# Service Information

Category <b>S</b>	<b>Repair Guidance</b>	Ref. No. R029/14	Page 1 of 4
Coverage <input type="checkbox"/> Distributor only <input checked="" type="checkbox"/> Please inform your dealers		Date Issued March 5, 2014	
Please convey this information to your <input type="checkbox"/> Director <input checked="" type="checkbox"/> General Manager <input checked="" type="checkbox"/> Warranty Dept. <input checked="" type="checkbox"/> Parts Dept. <input checked="" type="checkbox"/> Training Dept. <input checked="" type="checkbox"/> Field Rep.		Date Revised	
Applicable Model  Mazda3 (BM)	Applicable Countries or Specifications  Worldwide

## Subject: Buzzing noise from around driver-side dashboard

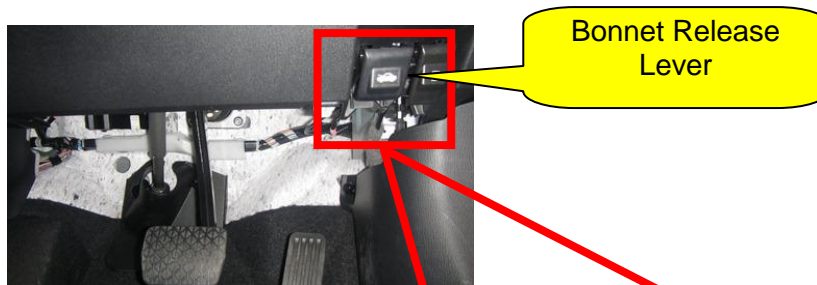
The buzzing noise may be caused by the bonnet release inner wire contacting the outer cable by impact from a rough road. The noise is heard from around the driver side dashboard.

The configuration of the bonnet release cable will be changed.

**With TUNER AND AMP UNIT (TAU)**

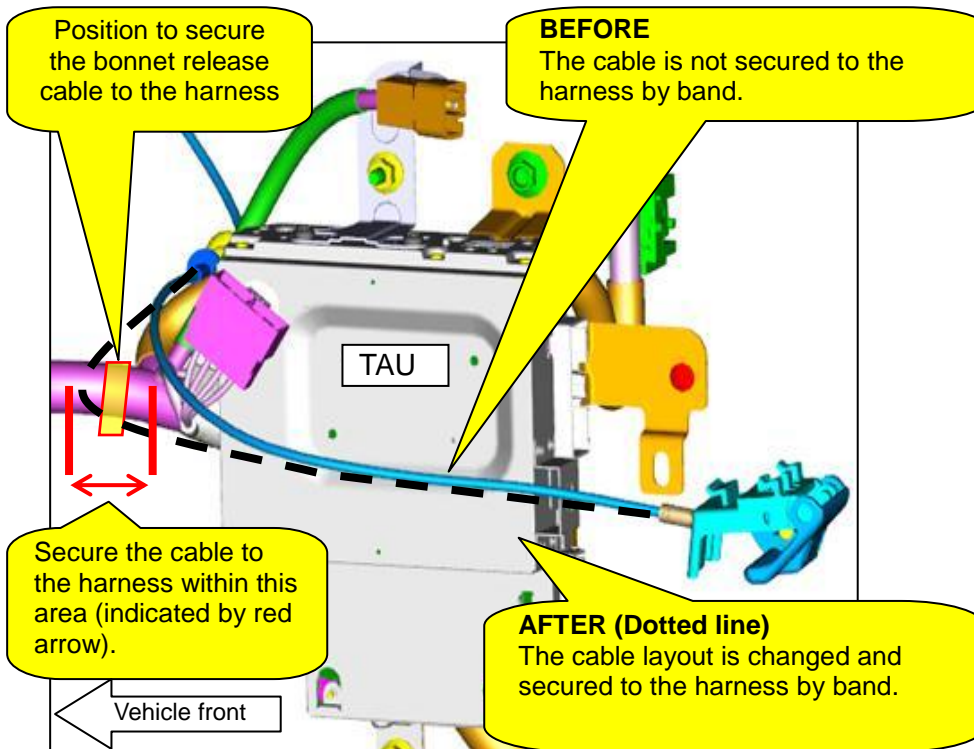
1. Verify customer complaint.
2. Change the installation layout (bending angle) of the bonnet release cable in order to avoid the inner wire shaking in the outer cable even when receiving impact, and secure it to the harness using a band as shown in the picture on the next page.
